### **Remarks**

The present application was filed on February 28, 2002. This Amendment is responsive to the Office Action mailed August 16, 2004 which provided an objection to the drawings and a rejection of claims 1-27. The Applicant has amended the specification and drawings in order to obviate the objection/rejection. The Applicant has furthermore amended claims 1-3, 5, 6, 13, 15, 16 and 18-22 to more particularly point out and distinctly claim that which is patentable subject matter. These amendments are proper, do not introduce new matter, are broadening of claim scope, are not narrowing in view of a prior art rejection, and place the application in proper condition for reconsideration and allowance of all pending claims.

### **Amendments to the Drawings**

FIG. 7

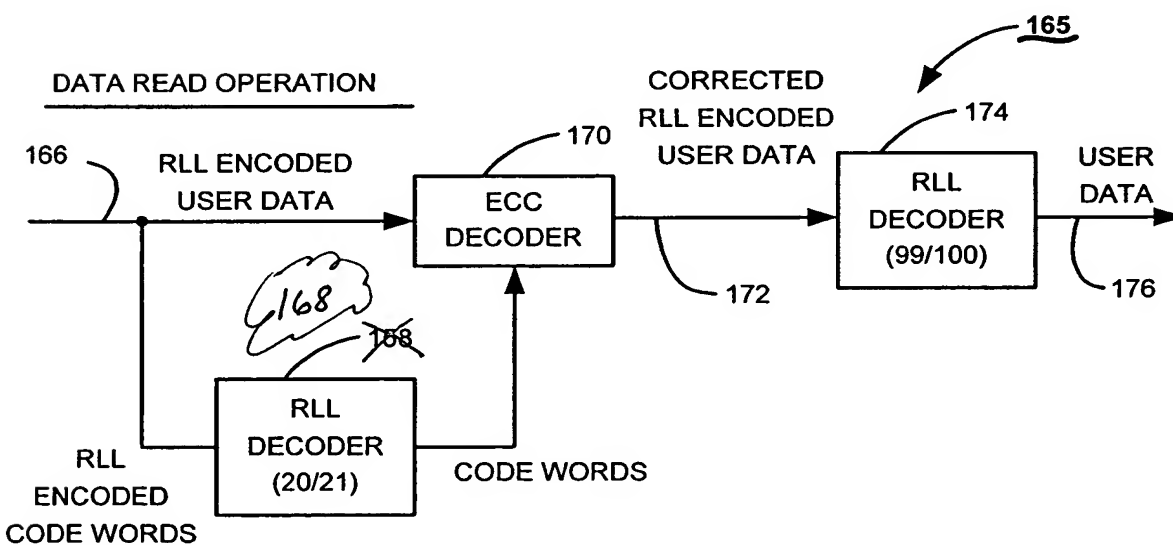
The attached sheets of drawings include changes to FIGS. 7, 10 and 11. Sheet 3/7, which includes FIGS. 6 and 7, replaces the original sheet 3/7. Sheet 5/7 (FIG. 10) and sheet 6/7 (FIG. 11) replace the original sheet 5/7 and 6/7. In FIG. 7, reference number 158 has been corrected to number 168, in FIG. 10, reference number 230 has been added and in FIG. 11, the words "AND TO RAM" have been removed.

FIG. 10

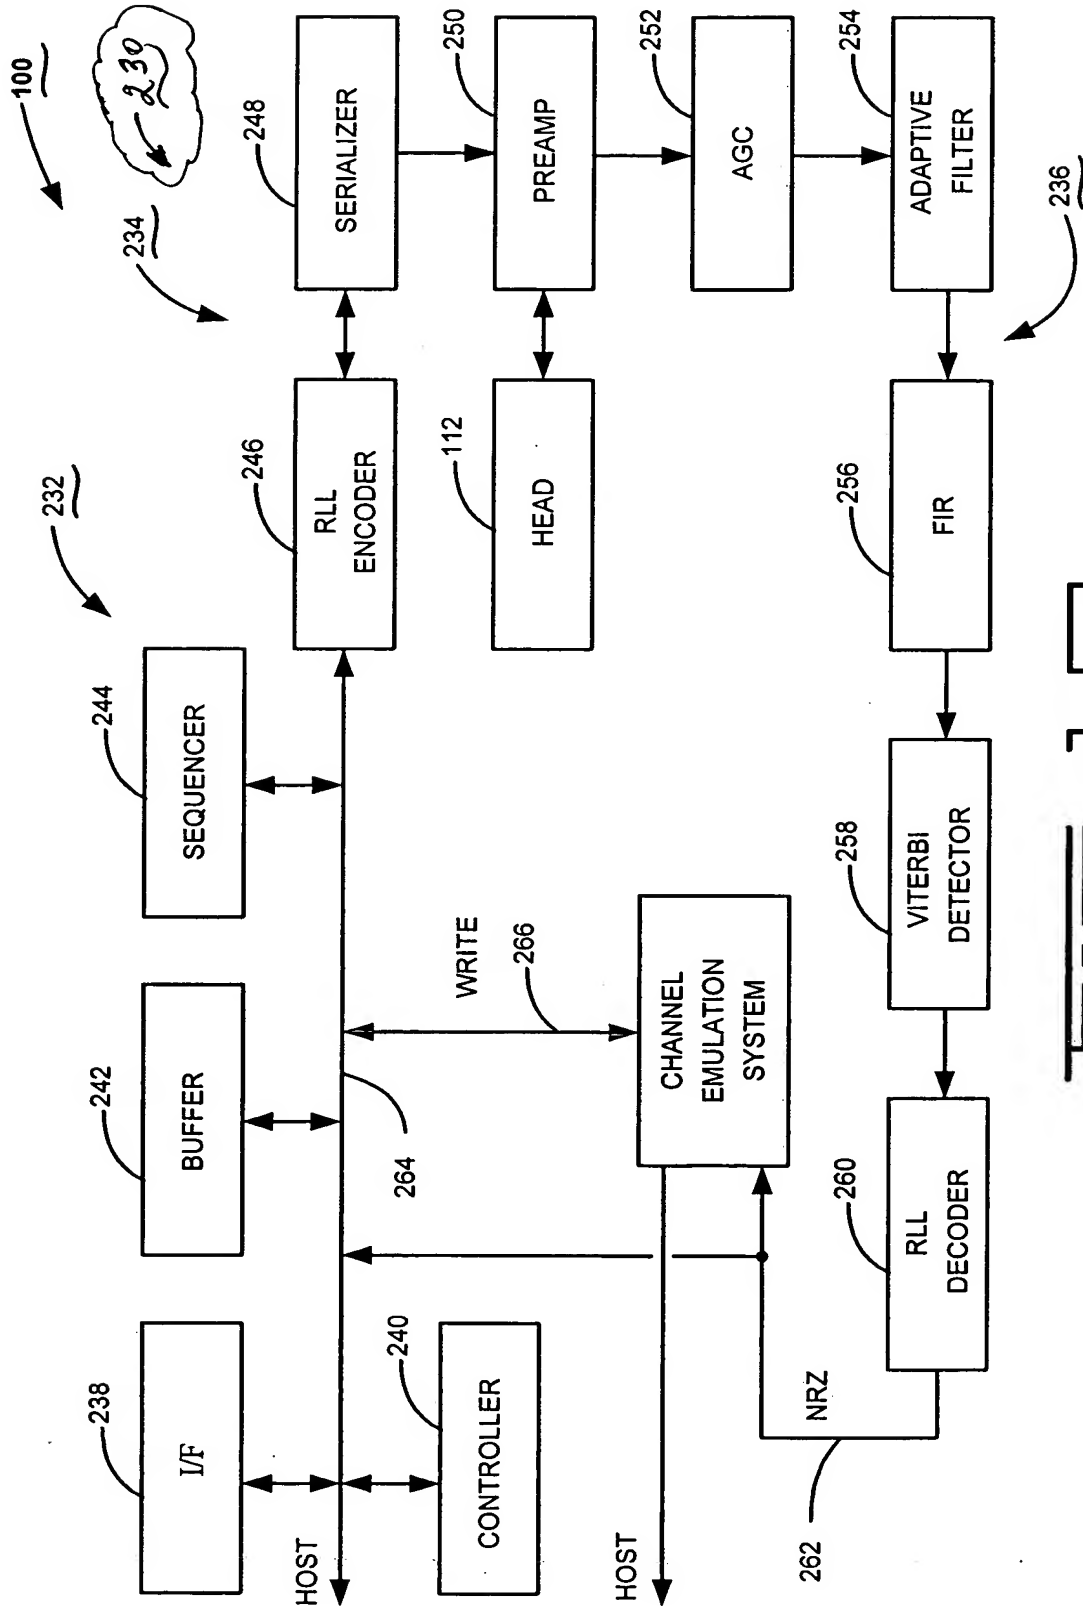
The drawings were objected to for not explicitly referencing the data channel 230. This objection is traversed on the basis that one skilled in the art recognizes from the specification and drawings that the data channel 230 includes the interface circuit 232, the write channel 234, and the read channel 236 (see specification, page 12 lines 25-30). The interface circuit 232, write channel 234, and read channel 236 are furthermore explicitly defined in relation to FIG. 10 ( see specification, page 13 lines 1-14). Nevertheless, the Applicant has amended FIG. 10 to show reference number 230, making more explicit that which was before explicit in order to obviate the objection. Reconsideration and withdrawal of the present objection are respectfully requested.
